DOCKET NO. 366

APPLICATION OF OPTASITE TOWERS LLC
AND OMNIPOINT COMMUNICATIONS, INC.
FOR A CERTIFICATE OF ENVIRONMENTAL
COMPATIBILITY AND PUBLIC NEED FOR
THE CONSTRUCTION, MAINTENANCE AND
OPERATION OF A TELECOMMUNICATIONS
FACILITY AT 52 STADLEY ROUGH ROAD,
DANBURY, CONNECTICUT

**PRE-FILED TESTIMONY OF SHARON CALITRO,
DEPUTY PLANNING DIRECTOR, CITY OF DANBURY**

**PRE-FILED TESTIMONY OF RONALD GRAIFF, P.E.
RADIO FREQUENCY CONSULTING ENGINEER**

EXHIBIT 2
PATH PROFILE 37 CARMEN HILL TO "POOR COVERAGE AREA"

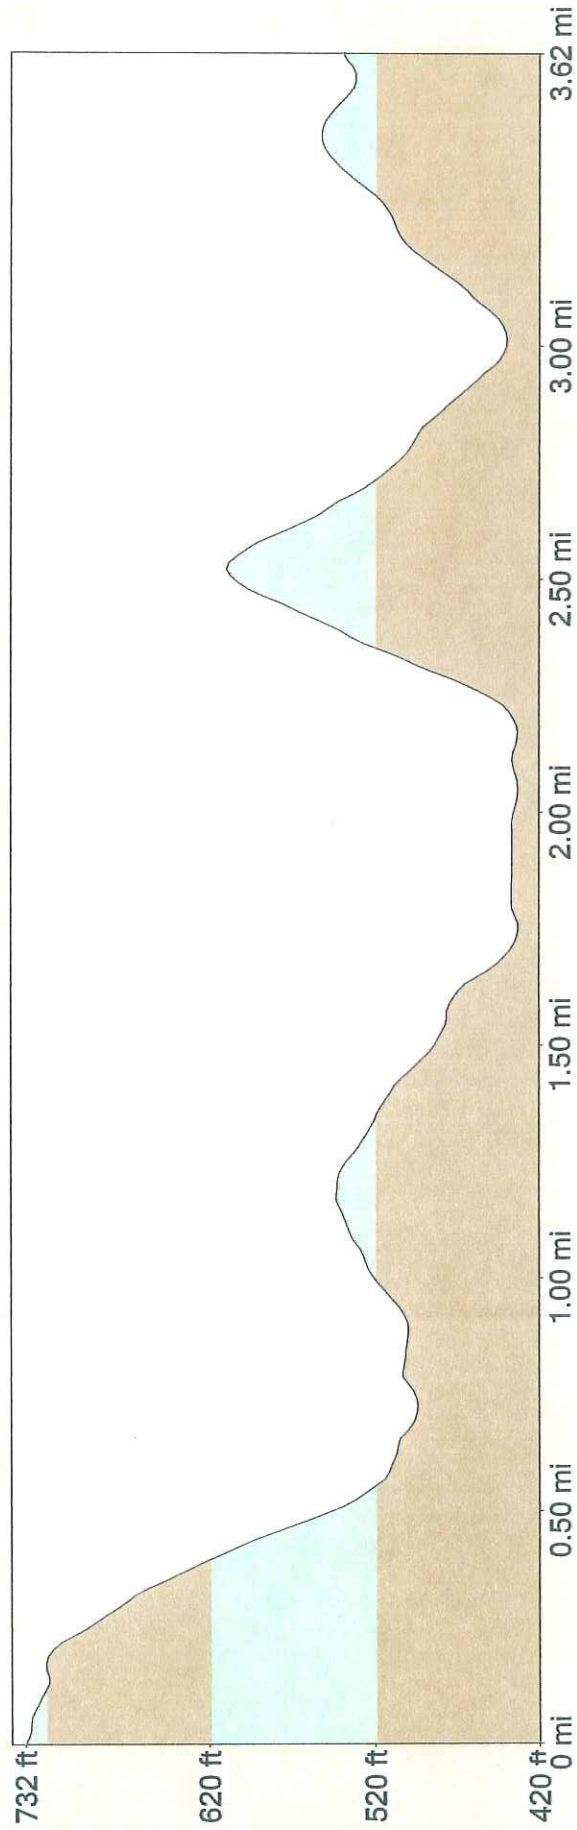
The coverage maps also suffer the flaw of not depicting coverage of all of the sites that are listed in the table "T-Mobile Surrounding Sites." Specifically, the following sites and their respective coverage are not shown on the propagation maps: CT-11924A, 78 Federal Road; CT-11196A, Carmen Hill; CT-11092J, 39 Sugar Hollow; CT-11197A, 18 Old Ridgebury Road and CT-11198A, 83 Wooster Heights Road. It appears in response to the CSC interrogatories that the applicant has now included the coverage of site CT-11924A. Particular attention must be paid to the lack of coverage depiction of Site CT-11196A, Carmen Hill. At that site T-Mobile has antennas at 298 feet above ground with a ground elevation of 686 feet AMSL. Attached to this testimony as **Exhibit 2** is a terrain profile derived from USCGS 7.5 minute topographic maps that depicts the terrain between the Carmen Hill site and an area along Stadley Rough Road that the applicants maintain is an area in need of coverage. This profile is without the antennas at 298 feet above ground. Please note the direct line of site coverage. This site will undoubtedly provide some coverage to the area purported to need coverage. All sites that are noted in the application should have their coverage depicted on the maps.

EXHIBIT 3
PATH PROFILE PROPOSED SITE TO "POOR COVERAGE AREA"

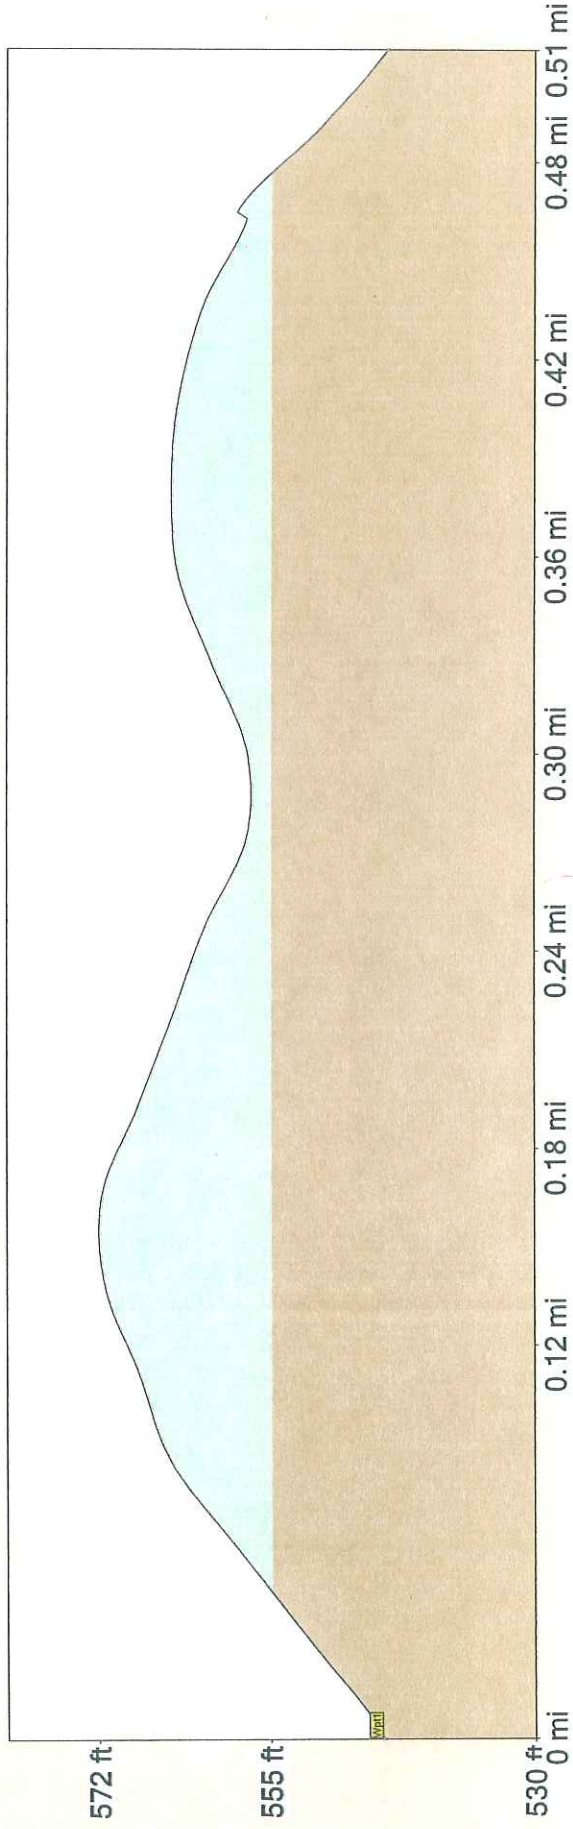
The applicants note that site 11 the water tank just 0.7 miles from the site has been determined by some unspecified radio frequency engineers not to provide coverage. There was not, however, a propagation map for this site included for review with the application. Attached to this testimony as **Exhibit 3** is the terrain profile, generated in the same manner as Exhibit 1 indicating the terrain between the site proposed at 52 Stadley Rough Road in the application and the same area of applicant stated poor coverage as in Exhibit 1. **Exhibit 4** is a terrain profile between the dismissed water tank location and the area of poor coverage. Note that these profiles, without the monopole or water tank depicted, still demonstrate, without question, the direct line of sight between the water tank site and the poor coverage area. It is incredible that the applicant could state that the site would not provide the coverage relief sought. The applicant should be directed to provide calculated coverage from the water tank site. This coverage map will be helpful in the critical review, once the model has been verified by drive testing.

EXHIBIT 6
PATH PROFILE FCI TOWER TO "POOR COVERAGE AREA"

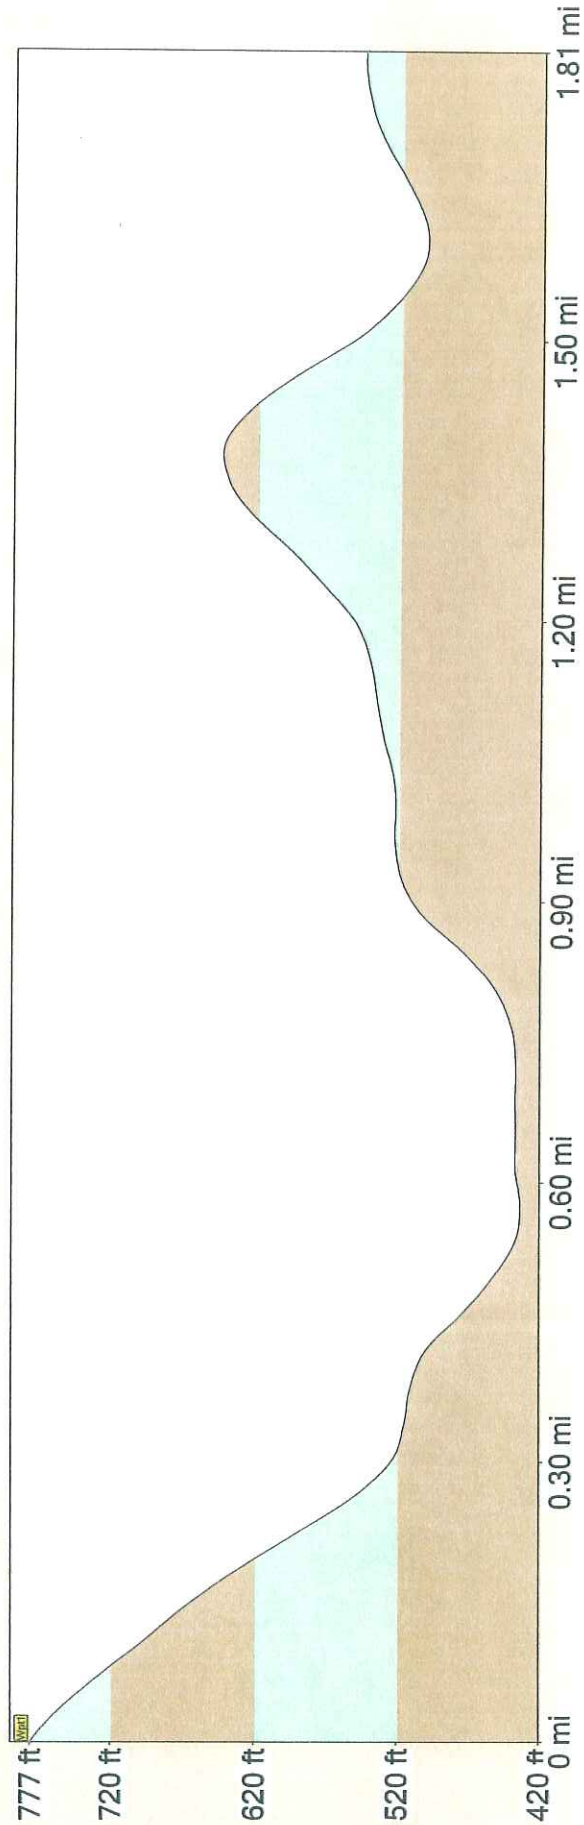
The site search summary, as noted, missed one possible site. There is an existing tower located either on or adjacent to the Federal Correction Institution on Padanaram Road in Danbury. Attached as **Exhibit 5** is an aerial photograph of the tower at this site. The ground elevation at this site is 782 feet AMSL. Attached to this testimony as **Exhibit 6** is a terrain profile as above between this site and the area of poor coverage. Please note the direct line of site path. In fact, this site was identified over 3 years ago during a Sprint application before the Danbury Planning Commission (pre CSC jurisdiction over PCS) to provide coverage to essentially the same area. At the hearing Sprint admitted that the site would serve its system to provide the coverage relief sought. The applicant should be directed to provide a coverage propagation map from this site at the **minimum** height necessary. This coverage map will be helpful in the critical review, once the model has been verified by drive testing.
